INTERNATIONAL DRIVE LUXURY APTS. MASTER PLAN

SUMMARY

Applicant's Request: The applicant is requesting approval of a Master Plan to allow an 8-story 329-unit luxury apartment building with internal parking and retail uses on the bottom two levels. The property is the last parcel in the City before crossing into Orange County.

CONCEPTUAL LANDSCAPE PLAN

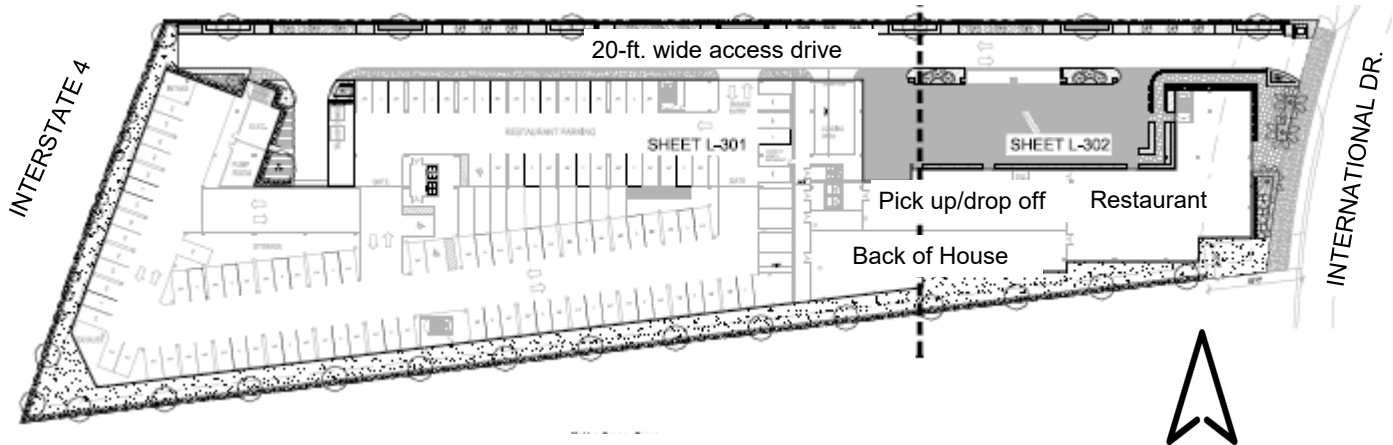
Buffers & Landscaping. The apartments and retail/restaurant uses abut other similar uses to the south, north and east (across International Dr.). Minimum 7.5-ft. vehicle-use/lot line buffers are required on all sides of the proposed use and must be installed per I-Drive Special Plan requirements.

1. All landscape plans must achieve the Minimum Required Landscape Score (MRLS) required for the proposed type and intensity of development. A digital spreadsheet (available at <http://www.cityoforlando.net/city-planning/landscape-code/>) showing compliance with the MRLS must be included when plans are submitted for permits.

2. The site is within the North International Drive Special Plan (SP), which requires lush tropical landscaping (increasing the MRLS score by 10%).
3. Direct pedestrian access must be provided from all building and garage entryways to N. International Dr.

ELEVATIONS

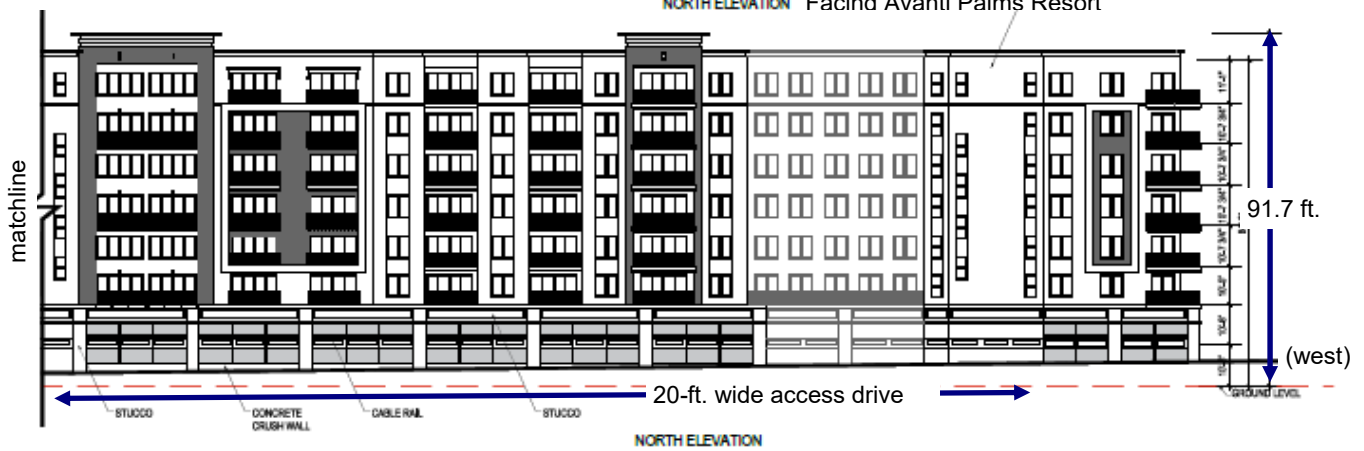
4. All building facades must be finished with the same materials and architectural detailing. Durable materials such as stone, brick, or limestone must be utilized at the base of the building (no EIFS or stucco).

5. Surface detailing, such as score lines, do not serve as a substitute for distinctive massing and articulation.
6. The principal façade must include a clearly articulated public entryway oriented towards N. International Dr. The entryway must include a substantial sheltering element, such as a porch, awning, arcade or portico.
